DATE: November 16, 2022
TO: Potential Respondents
FROM: Carrie Stoeckert—Senior Construction Contract Coordinator
SUBJECT: Questions #1
RFCSP752-23-261209CS
UNT Advanced Air Mobility (UAAM) Test Center

This document is being issued to answer questions that have been submitted as follows:

E1.01

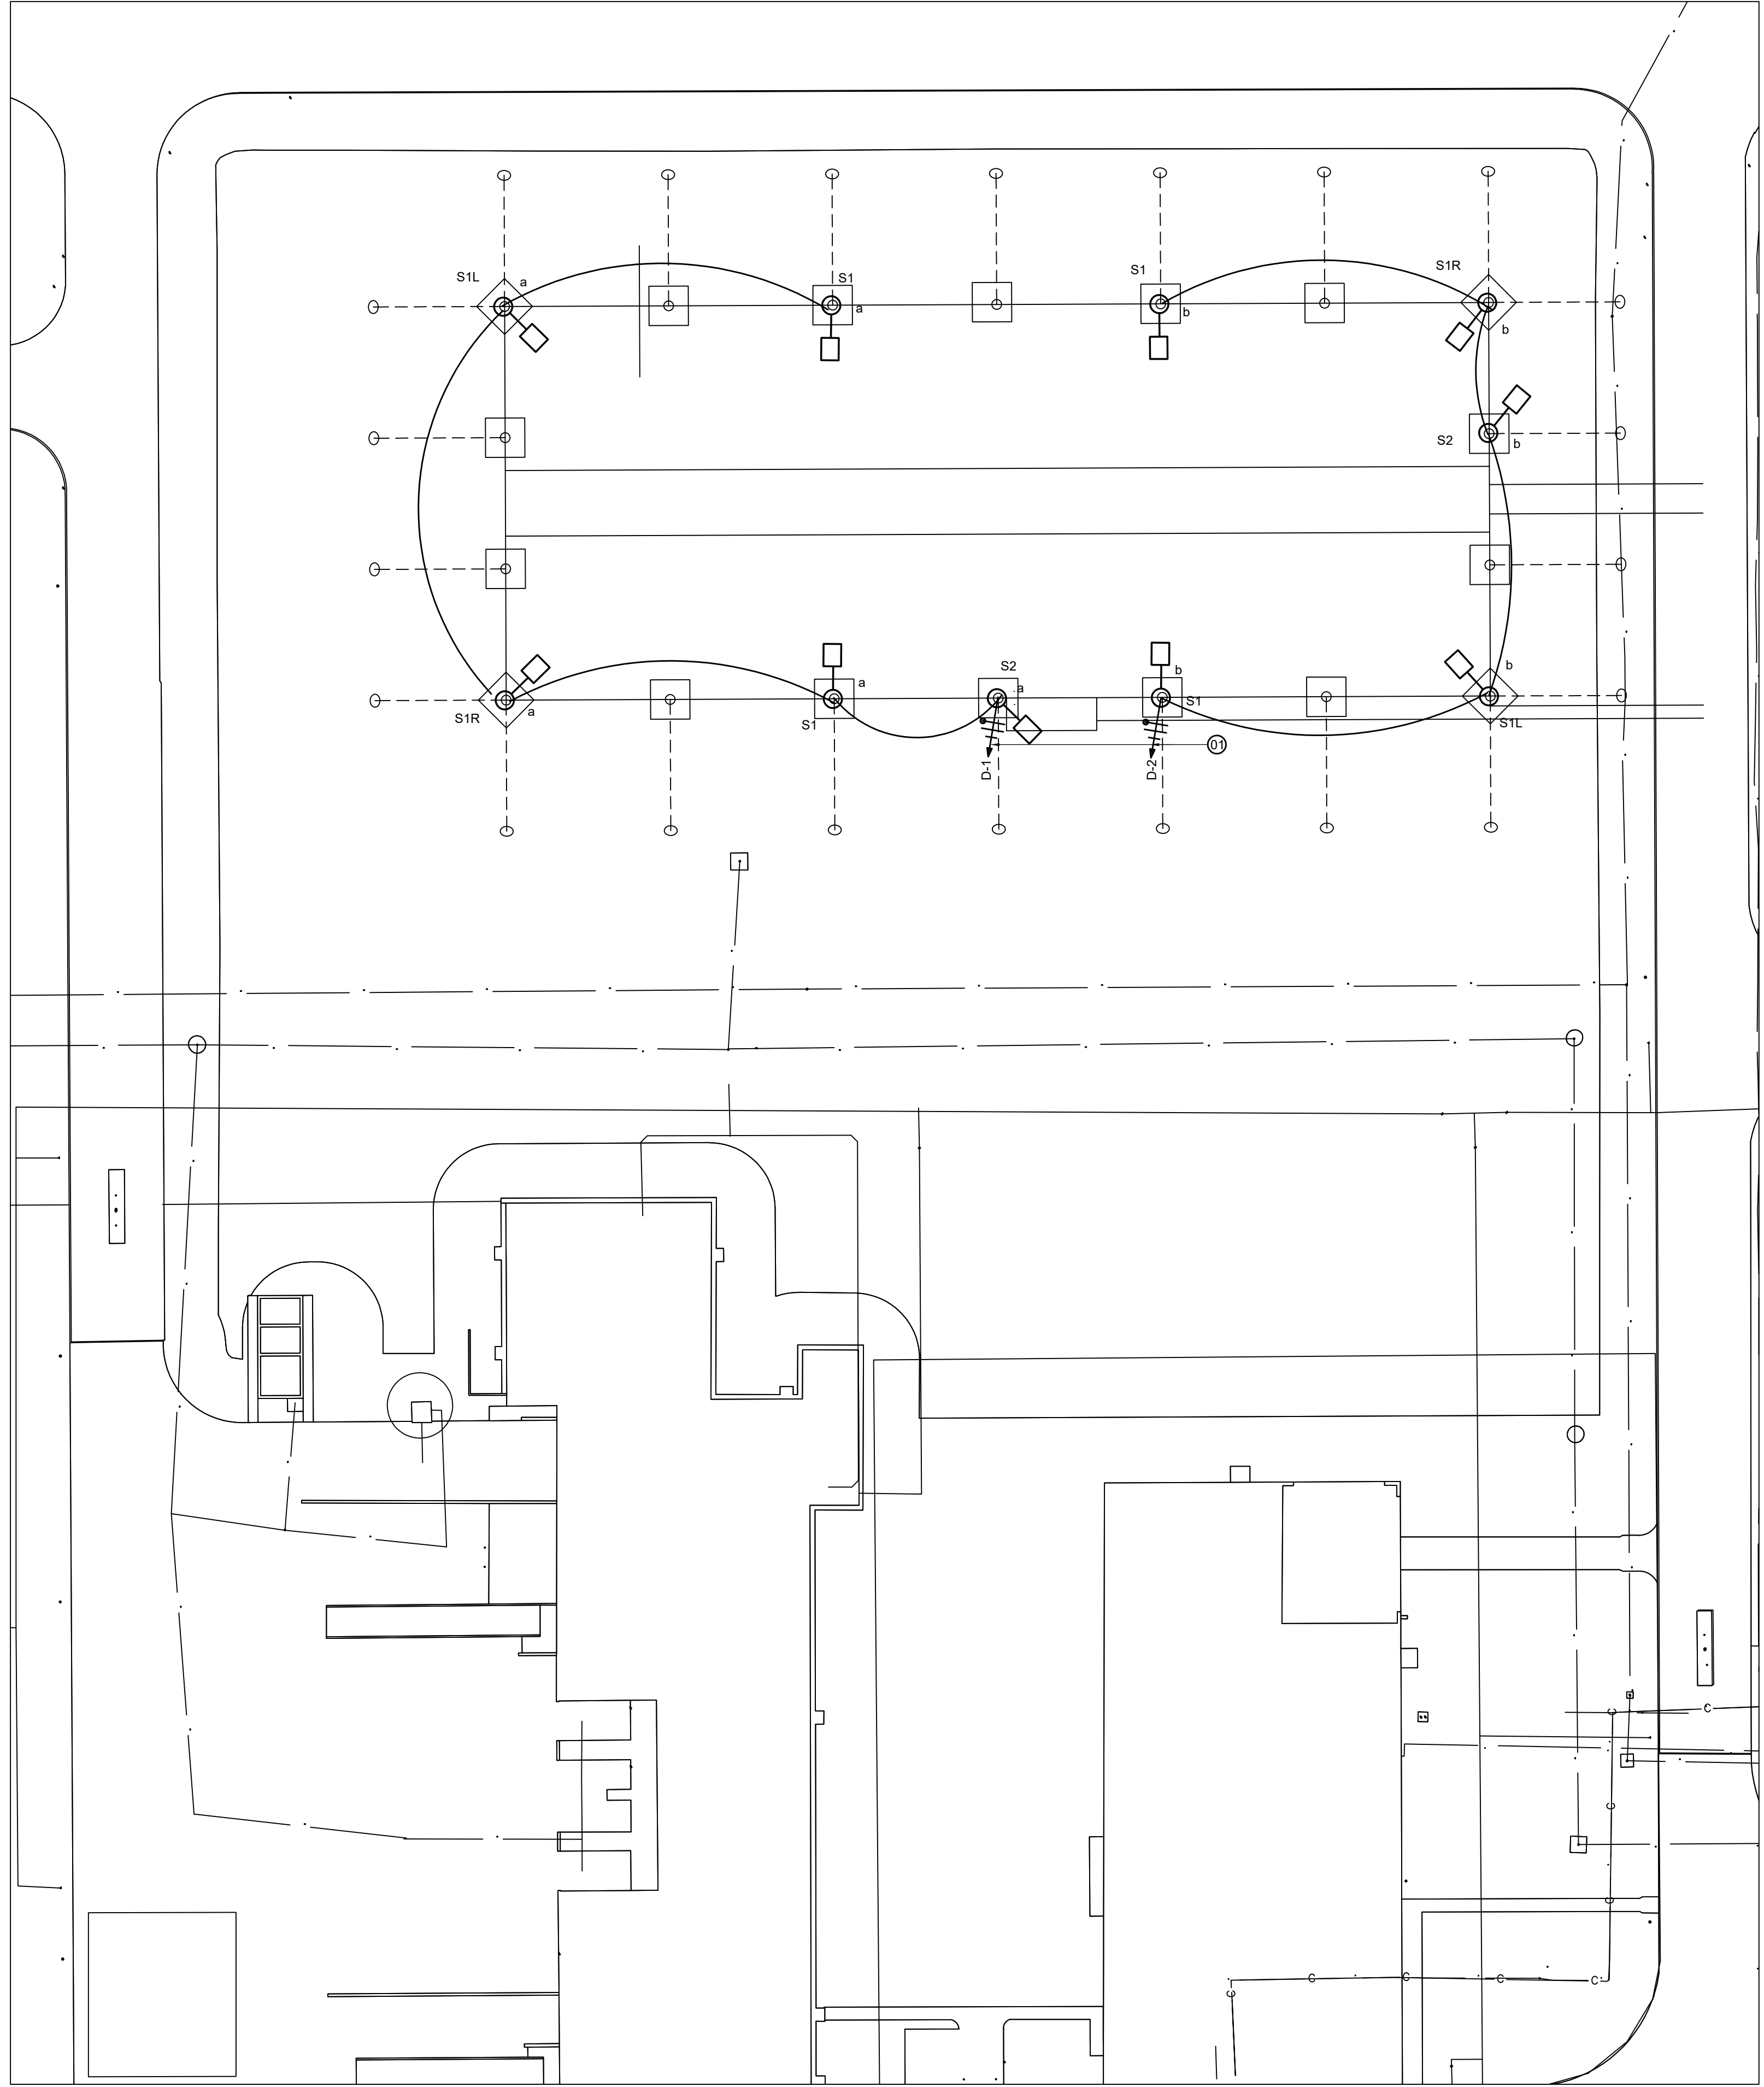
8. Please provide the location of the keyed switch for the pole-mounted site light fixtures shown on E1.01.
 - a. **The Intermatic time clock is lockable and is the keyed switched reference on the lighting set.**

E2.01

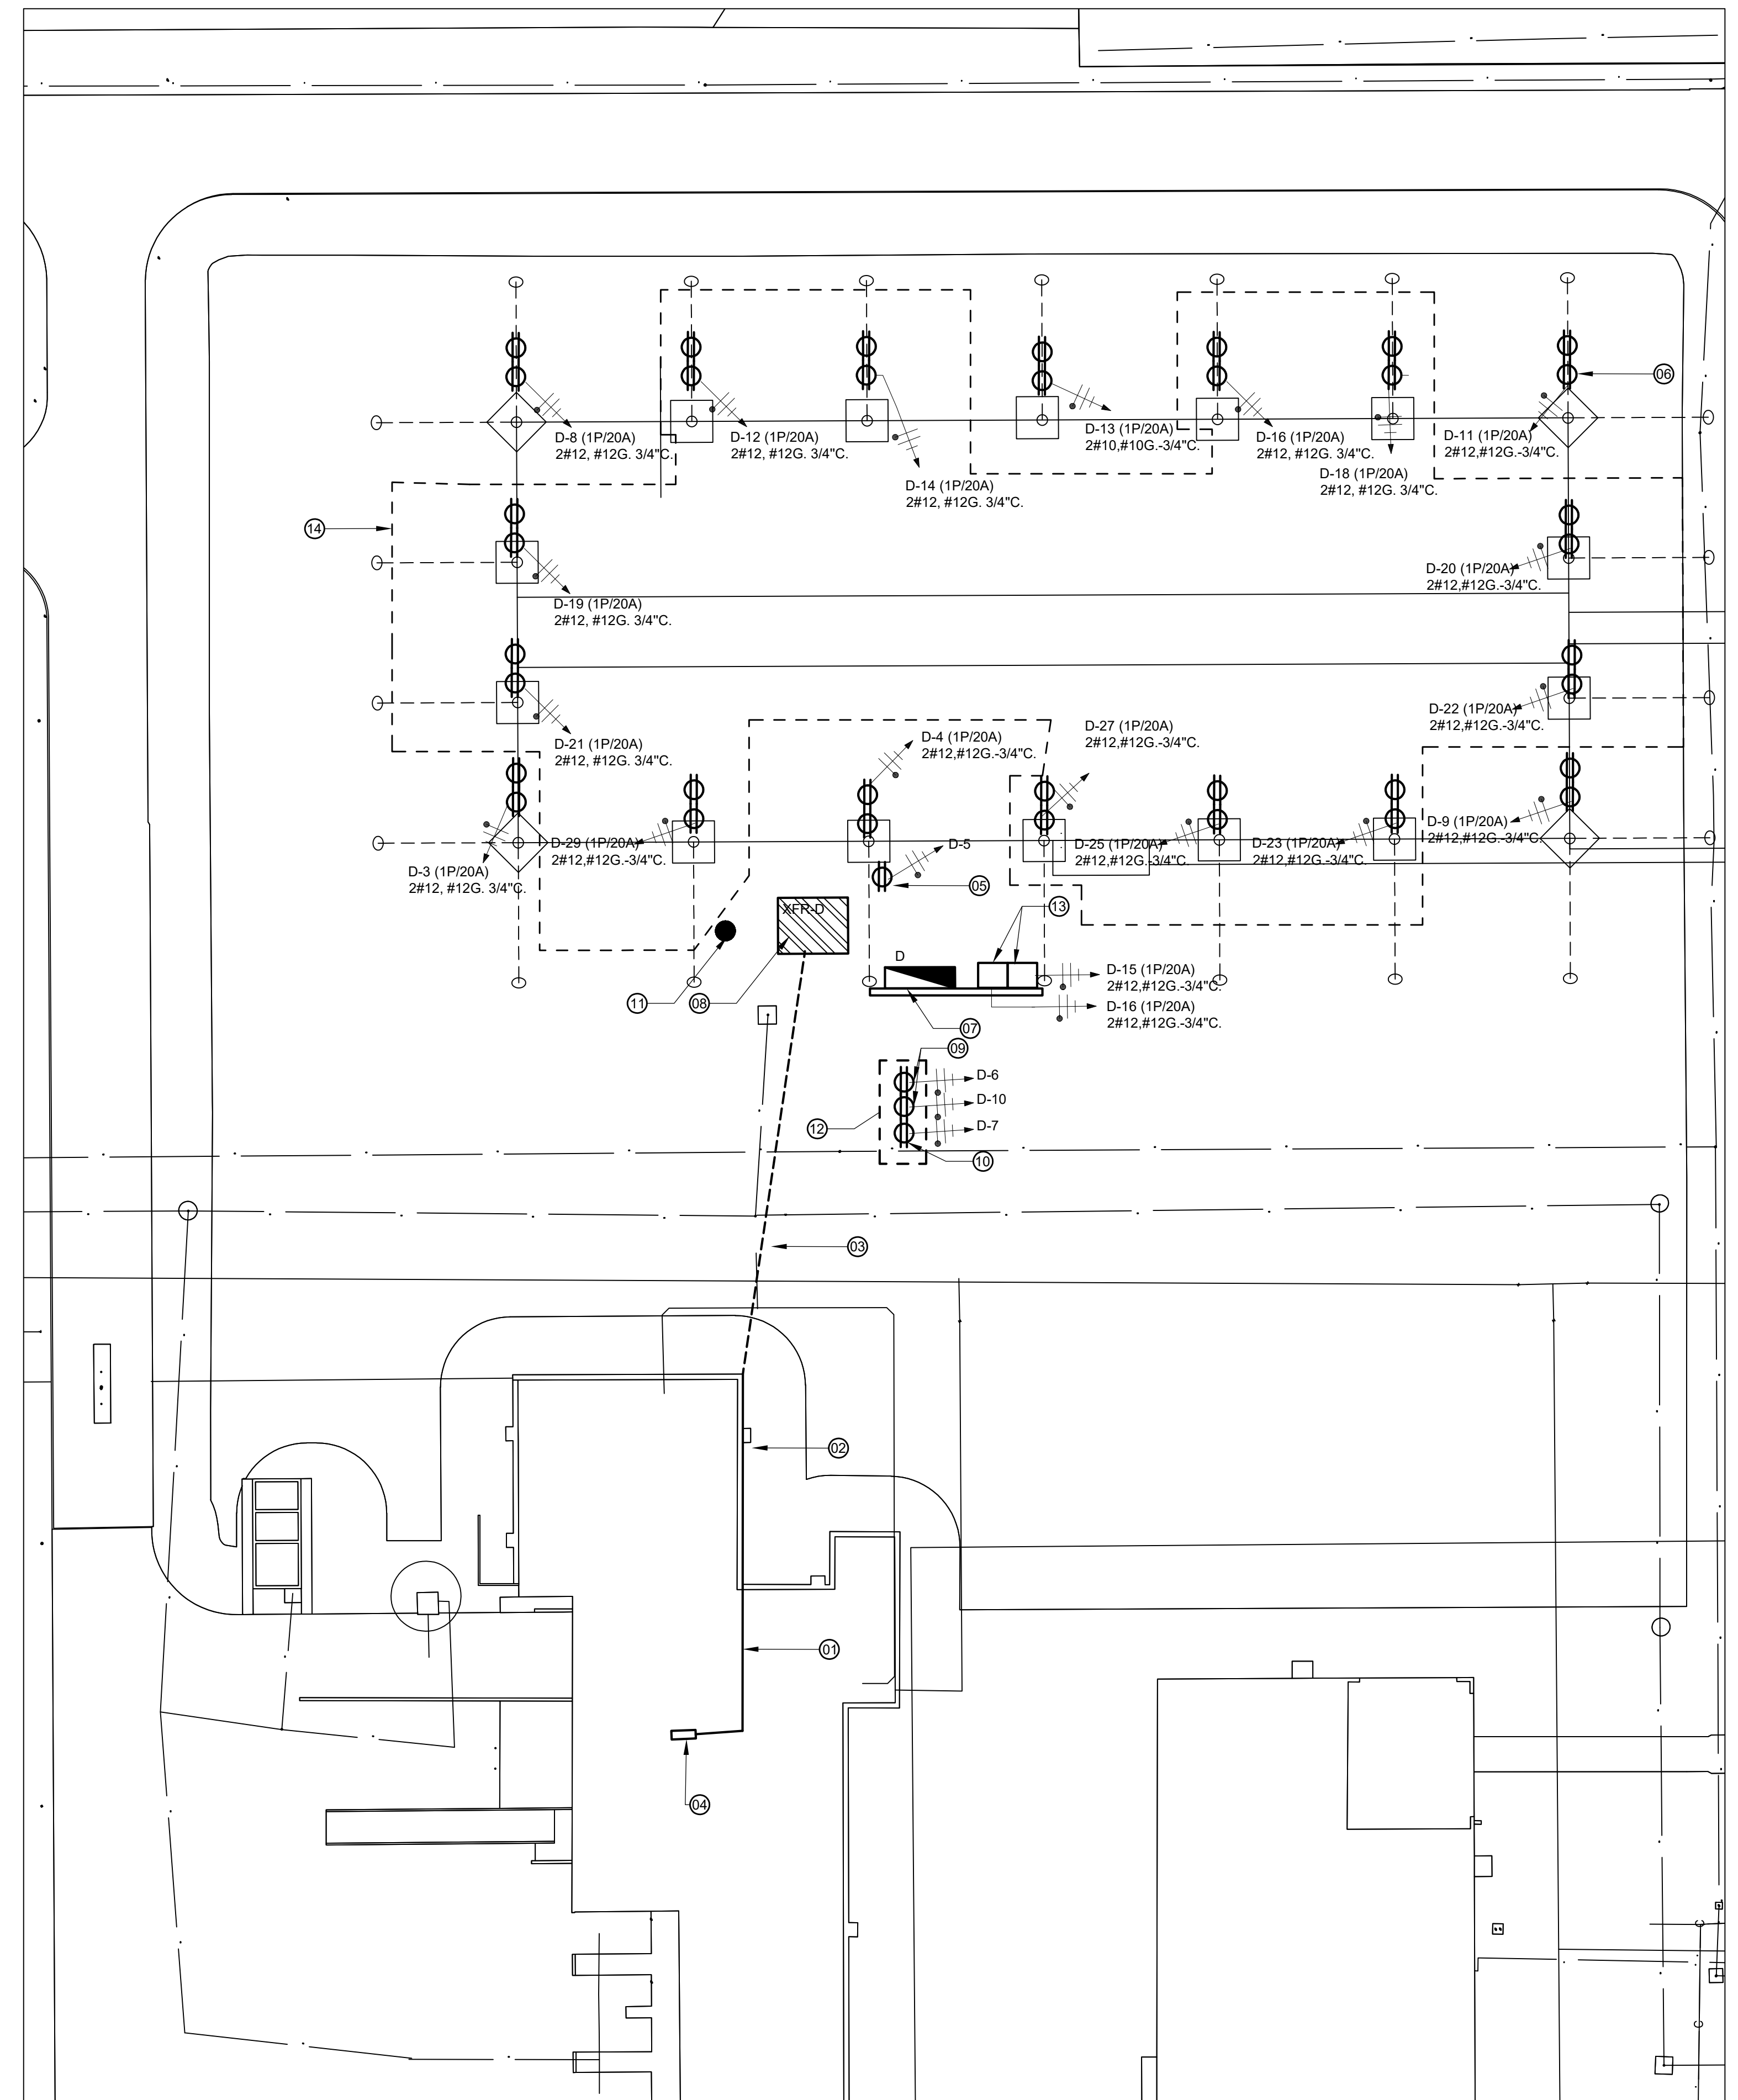
- a. **Electrical pad detail has been added to Sheet C9.00.**
5. The provided bid form indicates no alternates; however, the following alternates were listed on the documents; please clarify a. Sheet E2.01 - Add Alt #1: Provide (2) duplexes at pole mounted at 3ft and 10ft above ground. b. Sheet T1.01 - Add Alt #1: Provide (2) data drops at pole mounted at 10ft, 15ft above grade. Typical all poles with (2) drops. Sheet T1.01 - Add Alt #2: Provide (1) 6" C in lieu of (1) 4" C.

7. Sheet E2.01 keyed note #5 indicates to provide 1500W 5G equipment. Please provide make and model of required 5G equipment.
 - a. **Scope is to provide socket/power for 5G equipment for power consumption of 1300-1500w w/ 110v. Equipment will be provided by UNT at a later date.**

- a. **Revise bid form to include alternates attached.**
